JN 1229-001

May 12, 2025

RE: TTM 33536 – CEQA GUIDELINES § 15182 AND § 15162 COMPLIANCE (EIR, ADDENDUM NO. 4)

Phasing Plan Comparison

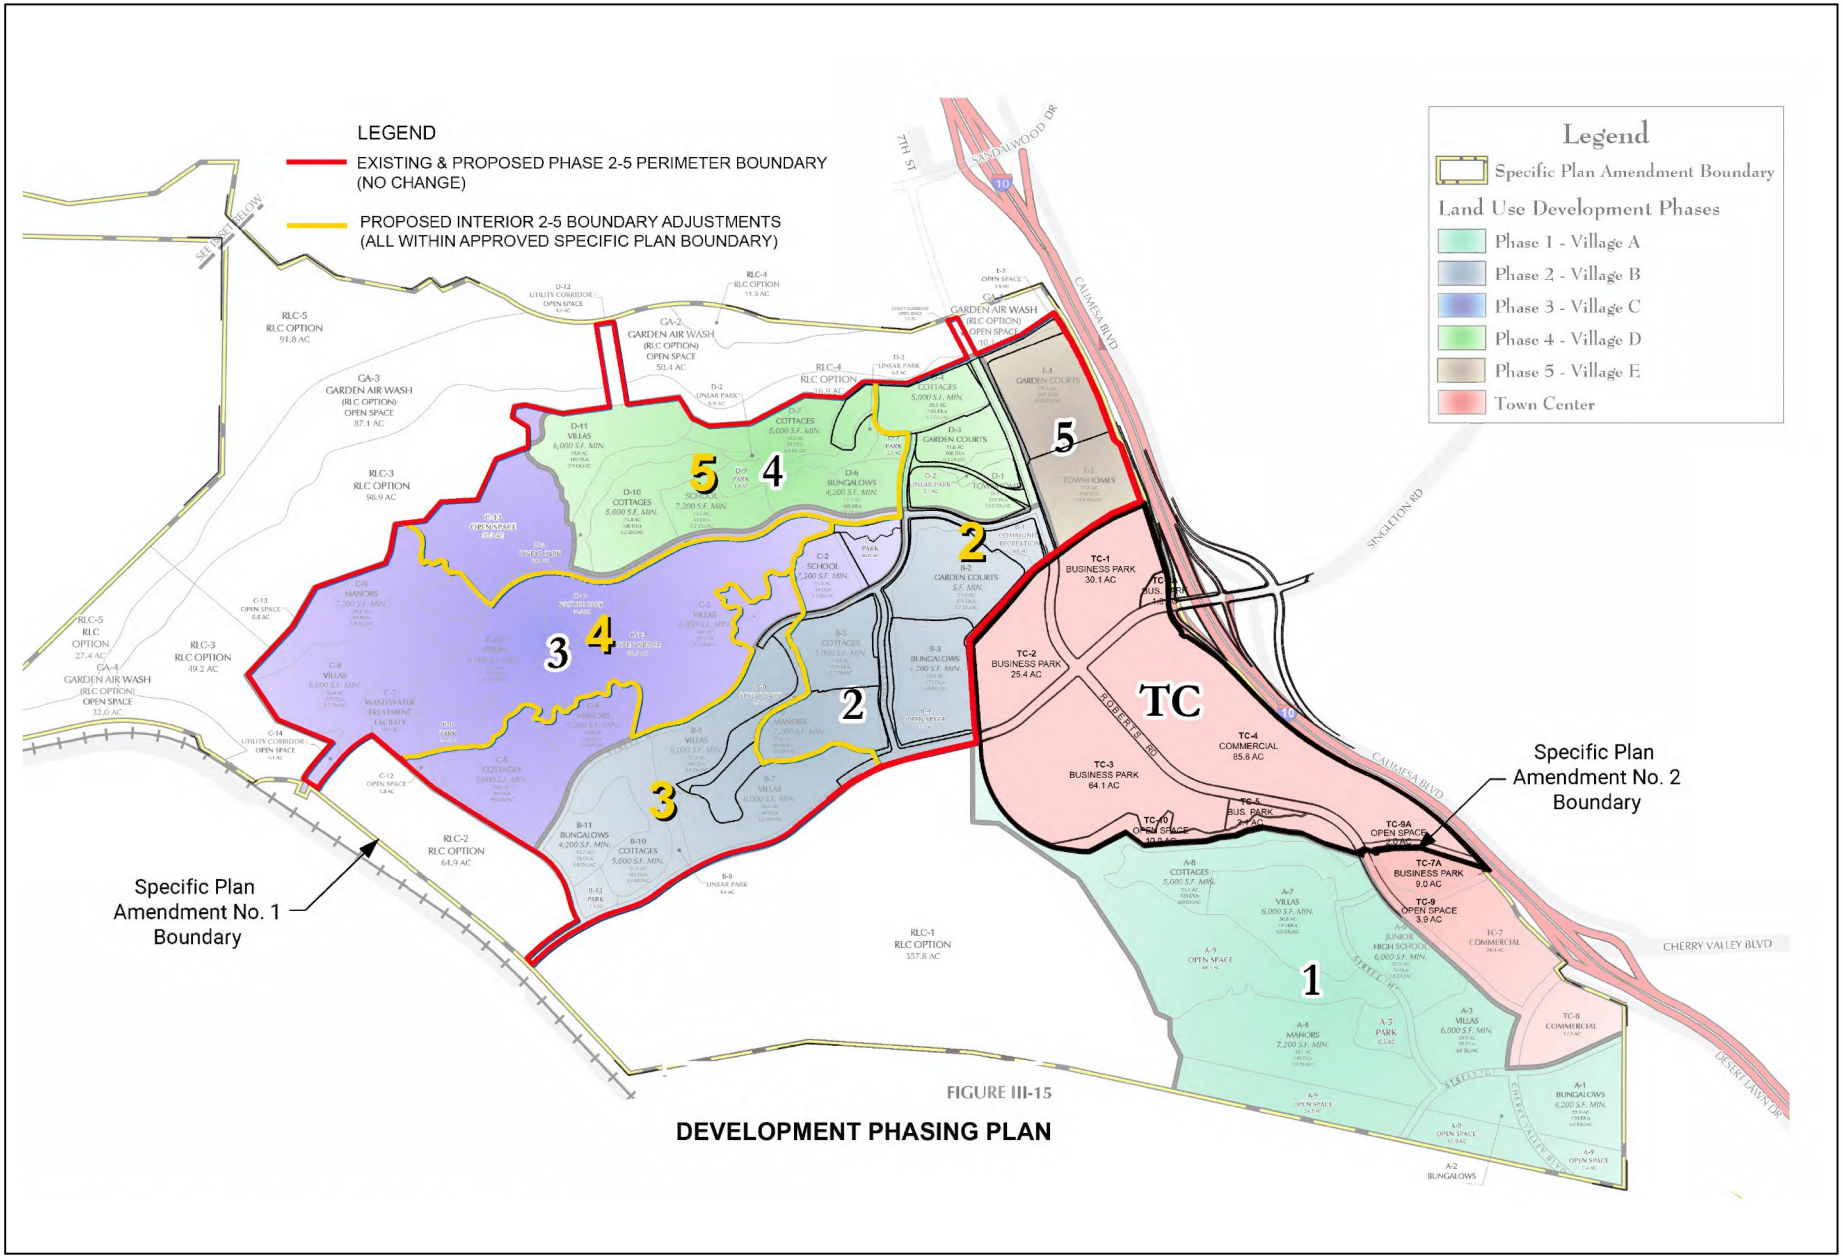
Figure 1, *Phasing Plan Comparison*, shows the revised phasing boundaries for the Project site compared to the phasing boundaries for the Project site under the Approved Project. The Revised Project applications are described in more detail in the following subsections. These modifications affect only the Project site.

- Development phases 2, 3, 4 and 5 (Villages B, C, D and E) have been reconfigured to take advantage of the sewer lift facility to be built adjacent to the Town Center. The proposed Phase 2 area drains to that lift station. Consistent with TTM 33536, a second lift station, previously planned will continue to be located at the southwest end of the property in Planning Area C-13 and will serve Phases 3 through 5.

- The boundaries of Villages B, C, D and E have been revised to be consistent with the reconfigured phasing boundaries and to more closely follow the approved TTM 33536, specifically to create a Phase 2 that will drain to the first lift station described above. A new TPM No. 38212 is created for conveyance of various planning areas within Phase 2.

Amended Tentative Tract Map No. 33536

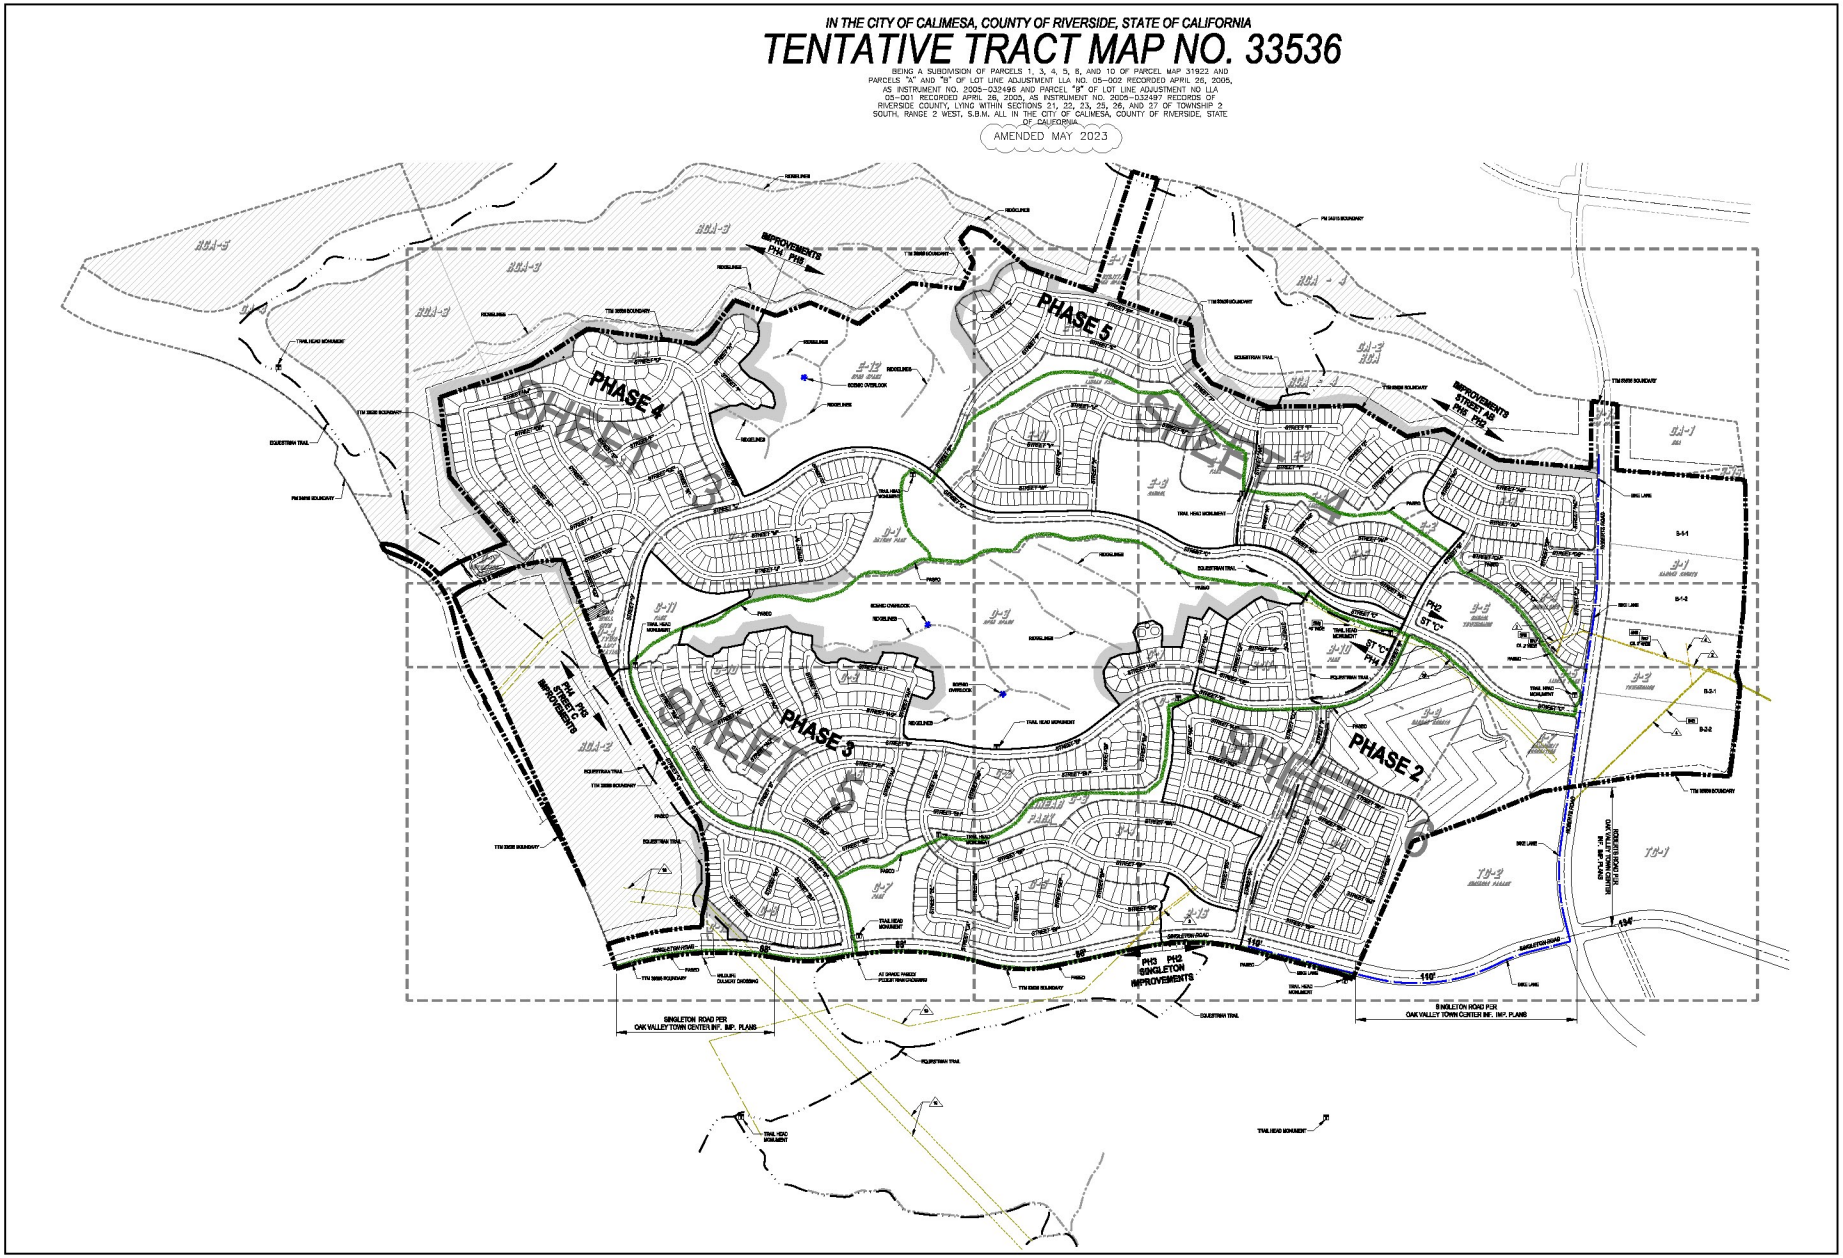
As shown on Figure 2, *Amended Tentative Tract Map No. 33536*, a revision to the previously approved TTM 33536 has been prepared to rephase TTM 33536 for future residential development consistent with the revisions in Amendment No. 5 to the Specific Plan. The proposed revision to TTM 33536 would reconfigure the existing parcels on the Project site to establish 11 separate parcels (APNs 413-290-018, -019, -022, -023, -024, -026; 413-200-046, -047, -052, -058, and -069) on 853.4 acres. The new. TTM 38212 (see Figure 3) is being prepared to subdivide Phase 2 for finance and conveyance purposes.
